# SERVICE LETTER No. L 138

Z 242 L aircraft, S/N: 0682

Aircraft manufacturer instructions for detected cracks and defects

### **ENCLOSURE No. 1 of Service Letter L138**

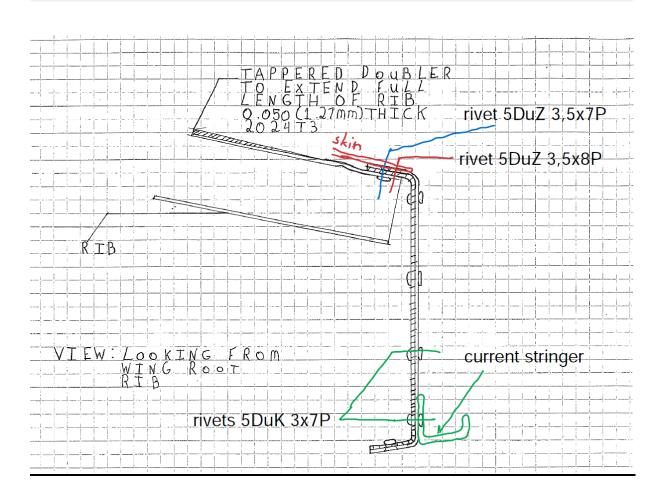
• Repair the aft spar cracks as described on pages 4-43 of the above-mentioned document. The cracked rib will be strengthened by the plate in accordance with the sketch provided by the operator's maintenance facility (see Enclosure No. 1)

- The rivets used for reassembly and plate reinforcement will be provided by ZLIN AIRCRAFT. The rivets must be positioned in accordance with the enclosed sketch (Enclosure No. 1) see annotations made by ZA.
- All existing rivet holes must be re-drilled for new rivet size to assure their proper alignment.
- New holes for rivets (ČSN 02 2302.5, size 2,6) will be drilled in accordance with the sketch provided by the maintenance facility and annotated by the manufacturer.

**NOTE:** use the rivets provided by Zlin Aircraft
